HORSHAM DISTRICT COUNCIL CONSULTATION

TO:	Horsham District Council – Planning Dept
LOCATION:	Thakeham Tiles Ltd Rock Road Storrington West Sussex
DESCRIPTION:	Outline application for the demolition of existing buildings, and the re-development of the site for up to 108no. dwellings (including a mix of private and affordable housing units), with associated infrastructure including vehicular, cycle and pedestrian access, parking, landscaping, open space and play provision, and sustainable drainage with all matters reserved except access.
REFERENCE:	DC/25/2087
RECOMMENDATION:	Holding Objection / More Information / Modification
SUMMARY OF COMMENTS & RECOMMENDATION: 2nd set of comments in green: Key concerns with the layout remain unresolved. While the previous permission is acknowledged and this will be an important planning material consideration for your decision making, the proposal is nevertheless assessed as having a detrimental effect on the landscape character and to a lesser degree on the visual amenity of the area and cannot be supported on landscape grounds. Please refer to comments below noting in particular recommendations at point 22 and 29. While the principle of develop

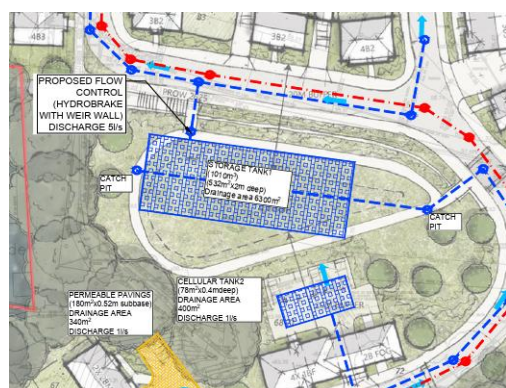
27. I have copied an extract of the open space calculations based on the OSSR, for 108 dwellings. These reflect those shown within the landscape strategy but provide a further split to the multi-functional green space subcategories:
